Memorandum

Project/File: Sherborn, Project Review
Date: January 7, 2025

Reference: Review of 34 Brush Hill Road Shared Septic System

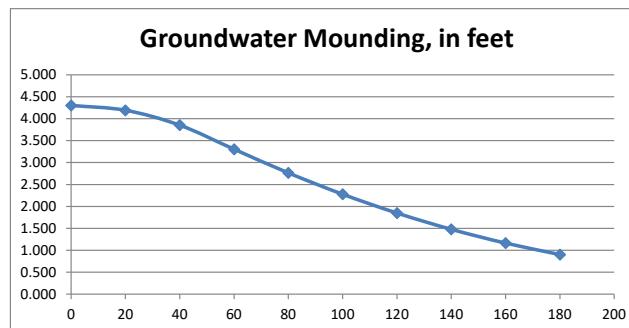
14. The 2-inch force main should be insulated in any area where less than 4-ft of cover is provided.
15. Mounding analysis is not required by either Title 5 or BOH Regulations for systems with flow less than 2,000 gpd. Nevertheless, an abutter's consultant (Horsley) has raised the question of mounding. To check this issue, Stantec ran Hantush mounding analyses for both original design conditions (Submittal E above) and latest design conditions (Submittal A above). Our comparative findings from these mounding analyses are presented in the table below (and supporting Hantush spreadsheets are attached) and discussed further below. The Horsley mounding analysis of the former (9.23.24) SAS design is flawed because of the following input errors:

- Basin Length and Width Input Error: The 9.23.24 design has 14 trenches which are 84-ft long, and total field length (including a 10-ft wide non-leaching area between the two sets of trenches) is 178-ft, and the Hantush method requires input of $\frac{1}{2}$ the area length and $\frac{1}{2}$ the area width, therefore these inputs should have been $x=89'$ ($1/2$ of 178') and $y=25'$ ($1/2$ of 50'). Mr. Horsley used a full field size of 180' x 50' and failed to use the required $\frac{1}{2}$ value inputs. We ran one Hantush analysis using Mr. Horsley's inputs just to check his results for the larger field (see version 1 in Table 1 below) and then ran another using corrected and revised inputs (see version 2 in Table 1 below) as a comparison for the larger leaching field mounding estimate.

- Recharge (Infiltration) Rate Error: Recharge rate for a 90-day mounding analysis is calculated as 80% of the Title 5 flow distributed over the leaching system

- Hydraulic Conductivity Value (K): MassMapper¹⁷ data on hydraulic conductivity (K) at the Site is reported as a max value of 10 ft/day and average value of 3 ft/day, but more relevant on-site testing by the Applicant found values of 4 ft/day and 6 ft/day, therefore we believe the min. on-site K value of 4-ft/day is appropriate, (Horsley used K= 3).

- Initial saturated thickness (h): This is the most significant variable in the Hantush calculation. Mr. Horsley used a value for h of 7.9-ft based on the depths of most on-site test pits. However, if the mounding issue is to be pursued further, then we believe that the saturated depth should be verified (see comment 16 below)

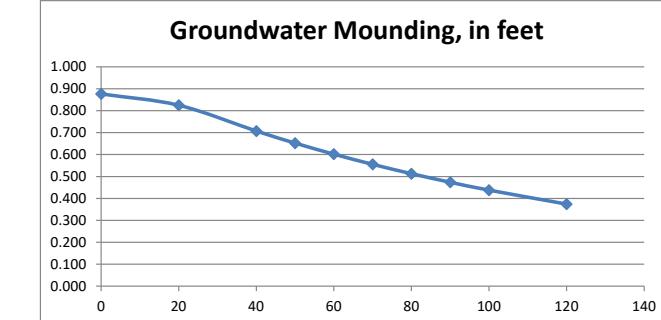
- Original design flow is 1,760 gpd, and leaching area is 50' wide and 178' long (89' + 10' + 89') = 8,900 sf
- Original design application rate = $(0.8 \times 1,760) / 7.48 / 8,900 = \underline{0.0212 \text{ ft/day}}$

We believe that the results for analysis version #3 (last row) in the table above provides the best current estimate of a mound height of (0.704-feet) that could form under the middle of the revised design leaching trench system. The mound height under the SAS area decreases with distance from the center of the field as shown in the Hantush output table and graph (Attachment 3). The mound would be seasonal and would not significantly reduce the effective treatment area below the SAS; however, the Board could ask that the elevation and grading at the SAS be raised to provide a consistent 4-ft

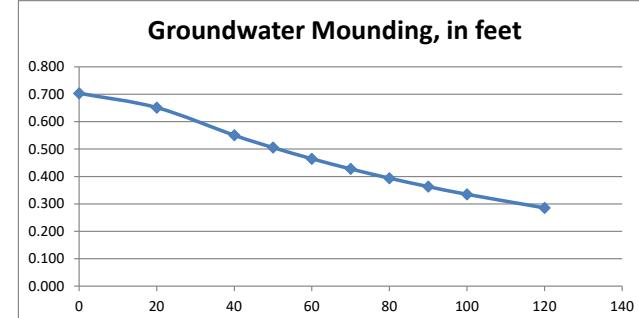
- Revised design flow is 1,320 gpd, and leaching area is 42' wide and 157' long (73.5' + 10' + 73.5') = 6,594 sf
- Revised design application rate = $(0.8 \times 1,320) / 7.48 / 6,594 = \underline{0.0214 \text{ ft/day}}$

separation¹⁹. The mound height decreases to 0.285-ft at 120-ft from the center of the SAS, and the water table gradient clearly drops also with distance from the SAS, therefore break out should not occur at any point on the Site. The mound elevation, when added to the ESHGW elevation below the system would not intersect with or come close to the side slopes or the downgradient retaining wall (19-ft from active trench, 15-ft from reserve trench). See Attachment 4 which is a sketch of the mound above ESHGW as shown on the Applicant's trenches cross-section.
